FLORIDA POWER CORPORATION
INTERIM DRAWING

DRAWING NO. B-208-047 54-R-01

INTERIM REV. NO. 1

UNIT NO. 3
ELEMENTARY DIAGRAM
REACTOR COOLANT PUMP 302 (RCP-10)
6500V, REACTOR AUX. BUS 30 UNIT 3

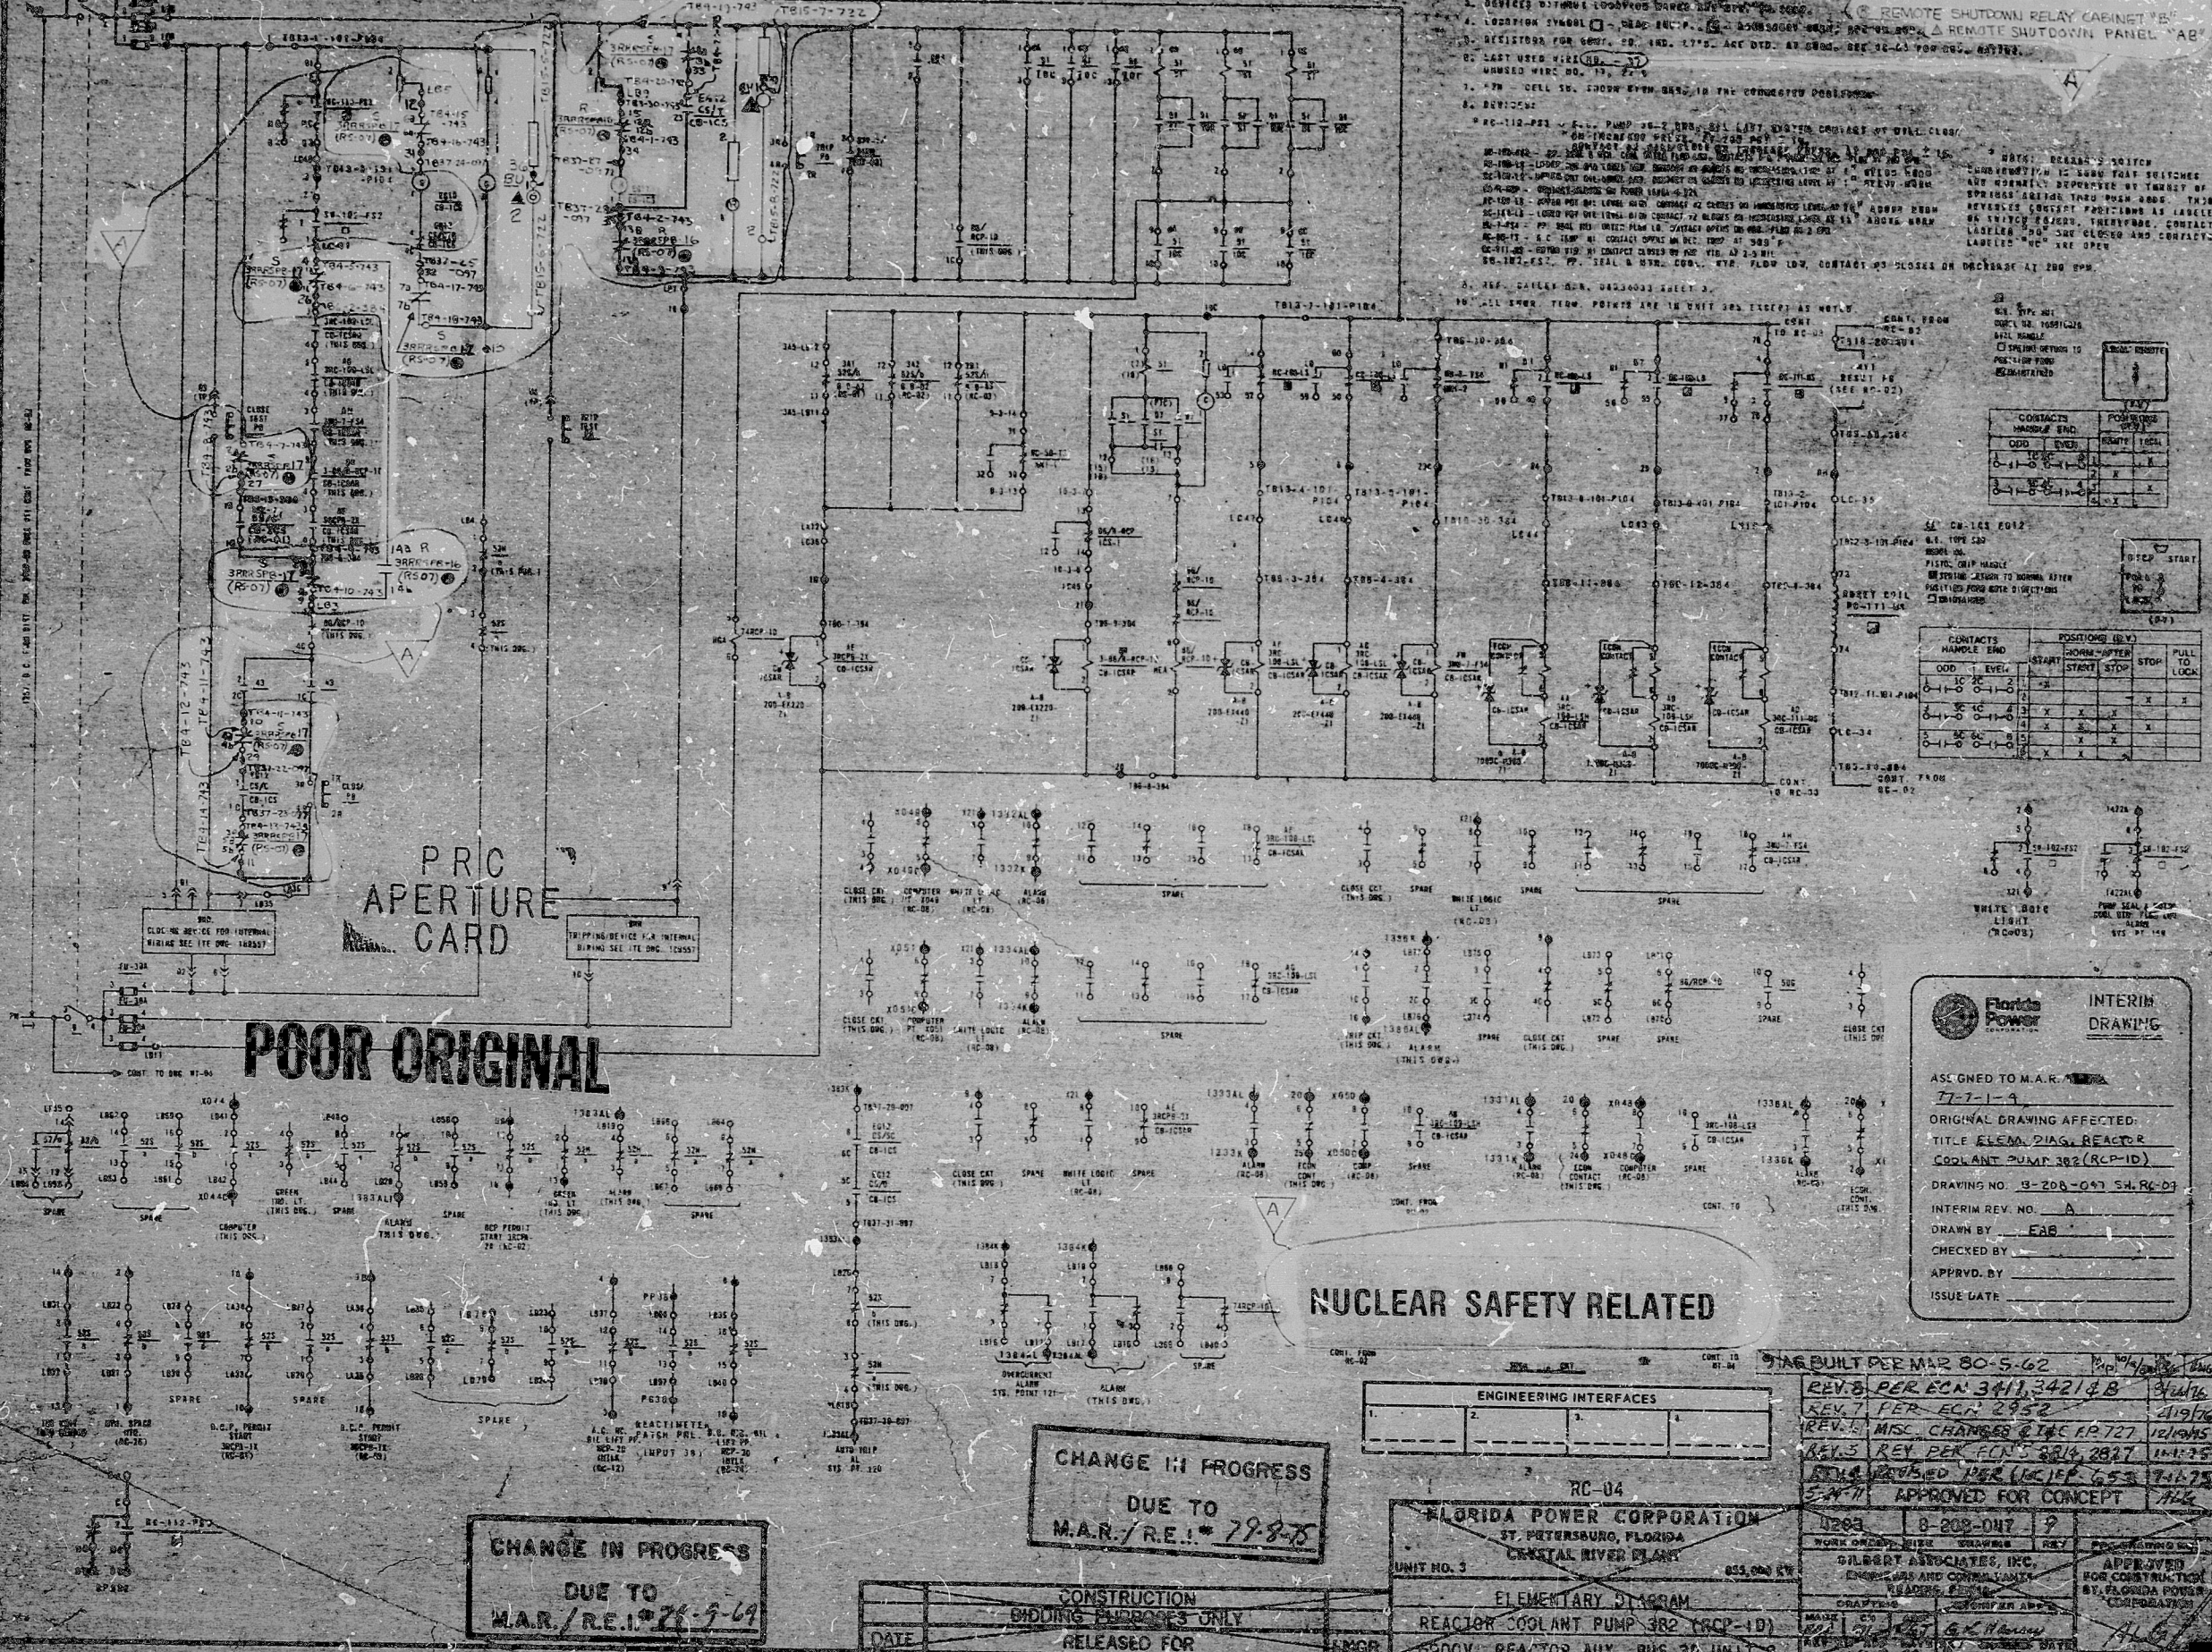
CHANGE IN PROGRESS
DUE TO
M.A.R./R.E. 77-8-8

CHANGE IN PROGRESS
DUE TO
M.A.R./R.E. 77-9-69
